SSD-32275057 REDFERN MIXED USE CO-LIVING HOUSING OBJECTION

SSD-32275057

Redfern Mixed Use Co-living Housing Objection

Figure 19: Excerpt of SSD2001 Proposed Basement Plan, showing approximate location of 1880's brick outhouse (now shed) to No. 9 Woodburn Street.

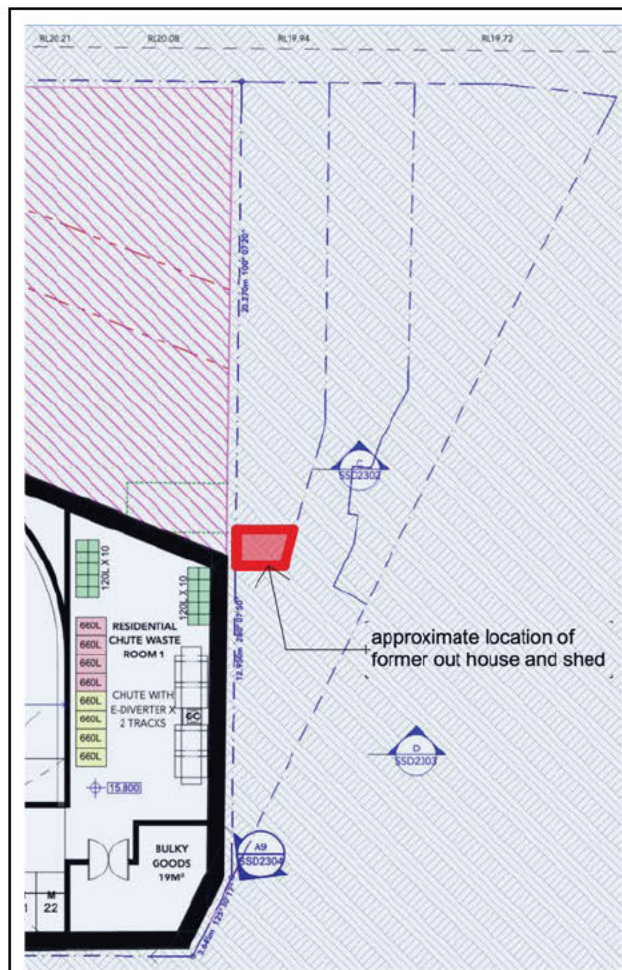
I have concerns about the proposed basement demolition adjacent to my 1880's former outhouse (currently back shed) which is located directly adjacent to the proposed residential chute waste room 1. I am concerned about the zone of influence of the proposed excavation and that proposed excavation and vibration will lead to the collapse of this former brick outhouse/shed.

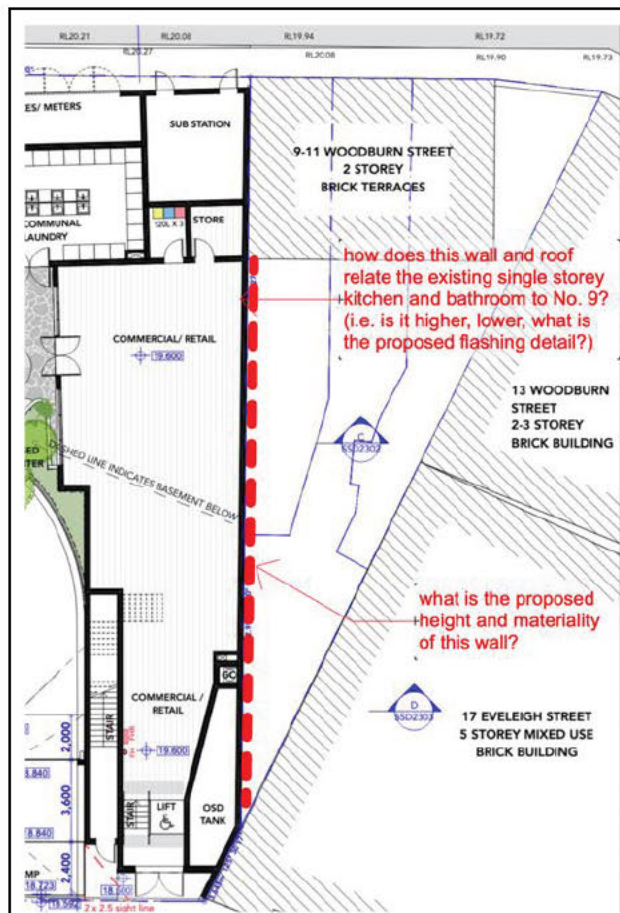
It is unclear from the drawings what the proposed height and material is for the wall adjacent to the boundary with No. 9 and No. 10 Woodburn Street to the new commercial/retail space.

Currently there is a painted brick wall from the former warehouse at No. 6-8 Woodburn Street and this forms a historic feature wall to my rear courtyard, No. 9 Woodburn Street, and the courtyard to No. 10 Woodburn Street. My preference is for this wall to be retained in-situ as is and for the new construction to incorporate it to the ground floor commercial/retail space along the boundary. Retaining the wall to the shared boundary with our properties would assist with providing more privacy for our properties during construction and create less disruption to our existing private open space. If it is not possible to retain this wall, I request that the new wall be the same quality face brick as used elsewhere in the development.

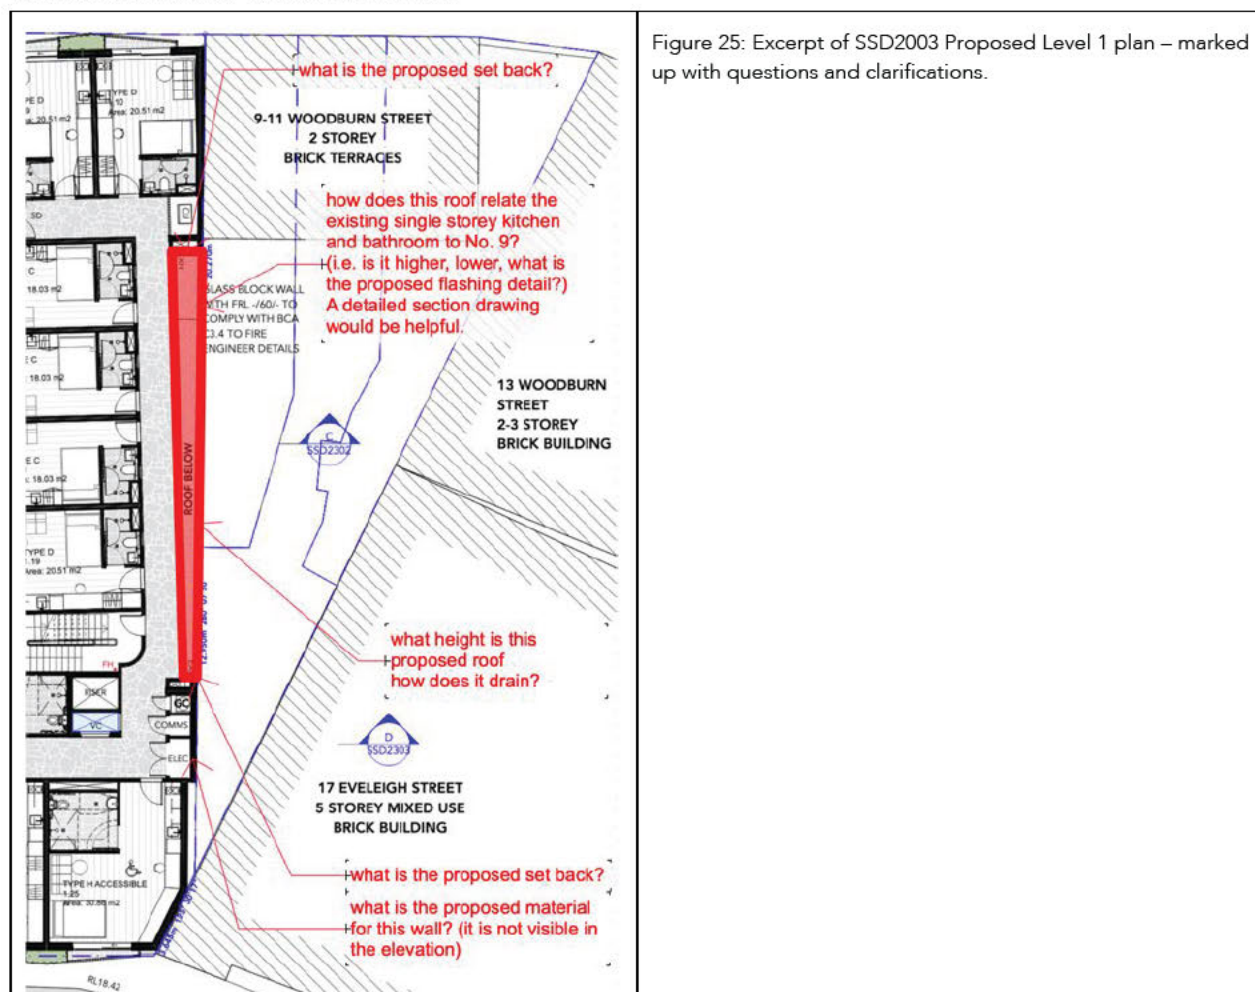
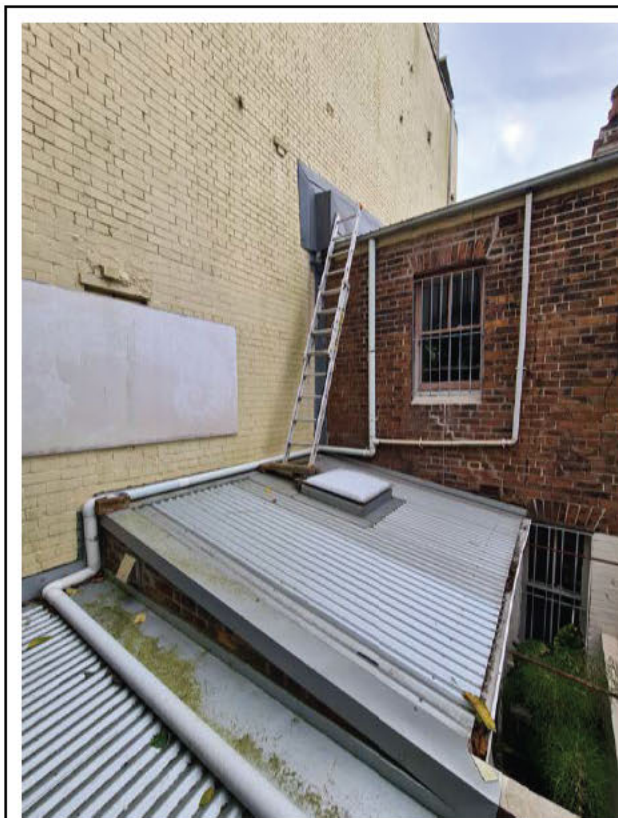
The proposed setback to the level 1 corridor along the shared boundary to No. 9 and No. 10 Woodburn Street is not dimensioned on the plans. I would like to know what the proposed setback is. I am in favour of the proposed setback of levels 1-4 from the adjoining southern boundary with No. 9 and No. 10 Woodburn Street.

I would also like to know what height the proposed roof is (section shaded red in the excerpt below), how this roof drains, and how this roof will relate to the single storey kitchen and bathroom of No. 9. It would be very helpful if a detailed section could be provided as part of the assessment in order to show how these items are proposed to be resolved. My preference is for the new wall to be slightly higher than my kitchen roof so that I can appropriately flash over the new wall. My desired outcome is for a detail that is as waterproof for both properties as possible.

I would also like to know what the proposed materiality is for the wall adjacent to No. 10 Woodburn Street as this is not shown on the elevations.

Figure 28: Excerpt of SSD2007 Proposed Level 5 plan – the area circled in red is the area of small garden and seating that I am concerned about.

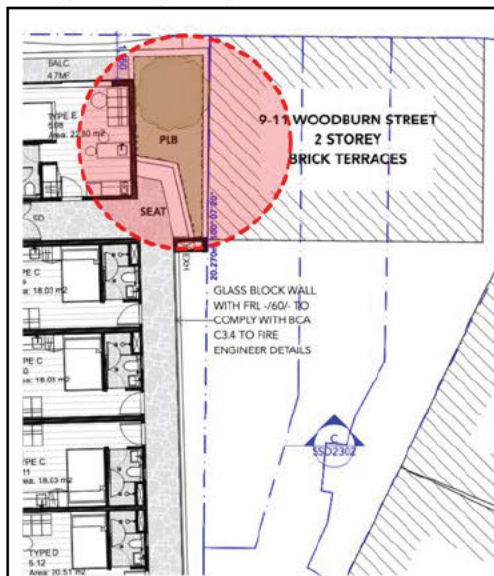
I am concerned about the small section of garden and seating proposed to the south eastern corner of the development adjacent to the front of No. 9 Woodburn Street. I am in favour of the proposed garden, however I am concerned about the potential for occupants to throw objects over the roof and on to my property. Occupants of No. 6-8 Woodburn Street have previously thrown rubbish and various items off the rooftop into my rear courtyard. I have no objection to recreational roof top space provided that the amenity of surrounding properties is protected from noise, overlooking and the potential to throw rubbish or objects into private open space.

Figure 30: Photo showing the existing parapet height on No. 17 Eveleigh Street. The proposed parapet should match the existing parapet at No. 17 Eveleigh Street.

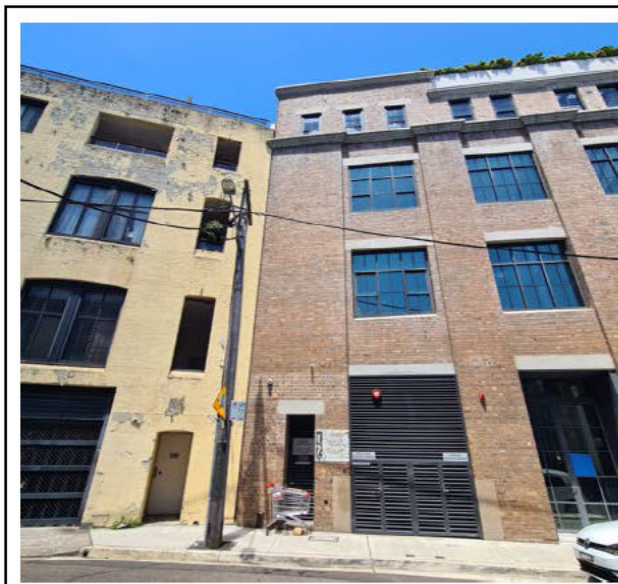
This elevation shows that existing brick parapet height of No. 17 Eveleigh Street is RL 35.800, the proposed street frontage height to Eveleigh Street should match this height at the southern end in order to form a coherent streetscape. The top roof of No. 17 Eveleigh Street is RL 39.170, and the bulk of the proposed Level 6 has an RL of 43.600 – that is 4,430mm higher than that approved on the site adjacent (which is an adaptive re-use project containing three original warehouse floor to ceiling heights which are considerably taller than modern residential floor to ceiling heights). There is absolutely no reason that a successful development cannot be proposed on this site that complies with the height limit of 5 storeys. The proposed 5th and 6th storey is excessive and unnecessary.

Figure 33: Excerpt of SSD 2403 South Elevation marked up with questions and clarifications.

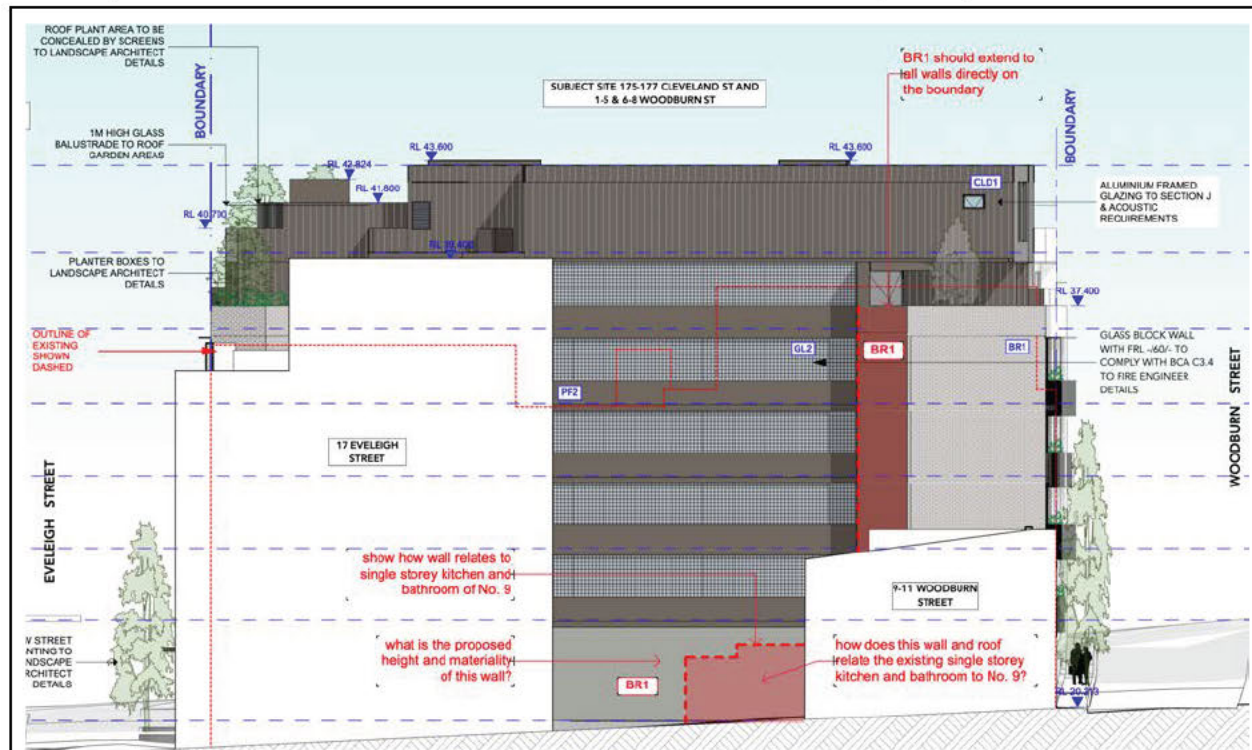
It is unclear from the drawings what the proposed height and material is for the wall adjacent to the boundary with No. 9 and No. 10 Woodburn Street to the new commercial/retail space.

The drawing shows a grey rectangle and is not labelled with the proposed materiality.

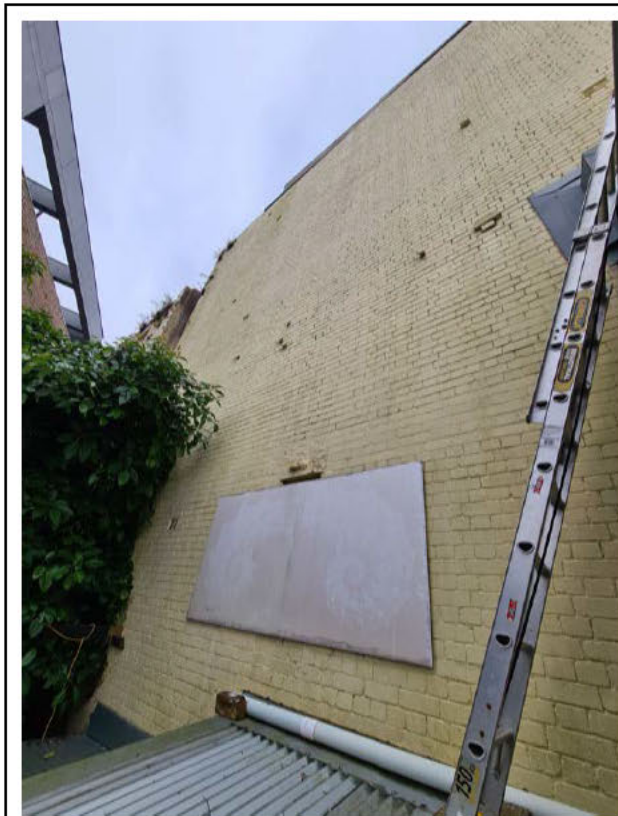
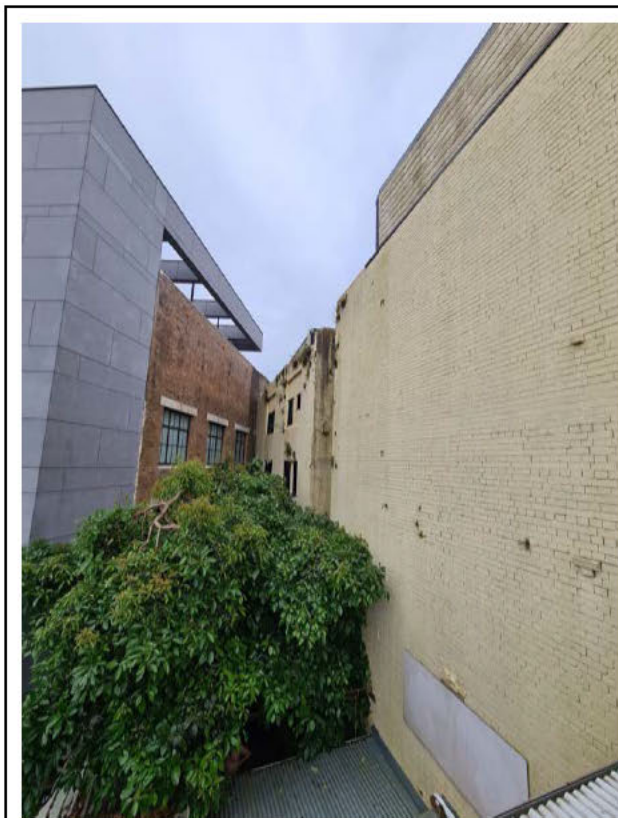
Should the planning department assess the paint finish as being acceptable, I would request that a lighter colour (not white) that the 'dark bronze' proposed be used so as to a maximise reflected, ambient light into the already dark and overshadowed private open spaces of No. 9, 10 and 11 Woodburn Street.

I request that an additional drawing of the South elevation be produced and exhibited to the neighbours showing the full extent of the development and proposed materials along the southern boundary. Although it is useful to see the development in relation to the existing form at No 17 Eveleigh Street, inclusion of No. 17 Eveleigh means that the full proposed elevation to the southern boundary is not visible. I have several questions about what is proposed to this elevation that we look at everyday.

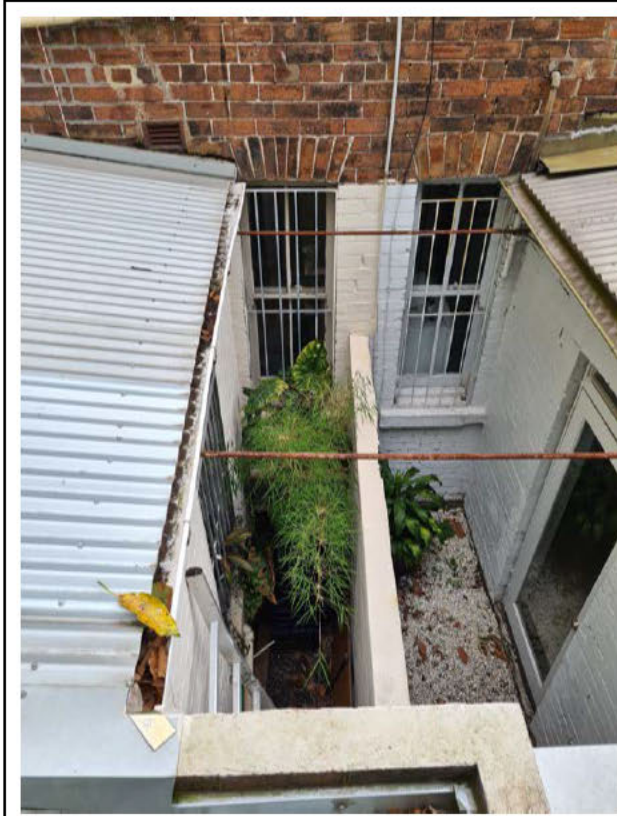
I also request that elevational shadow diagrams be produced to show that there will be no additional overshadowing to living room windows of No. 9 and No. 10 Woodburn Street.
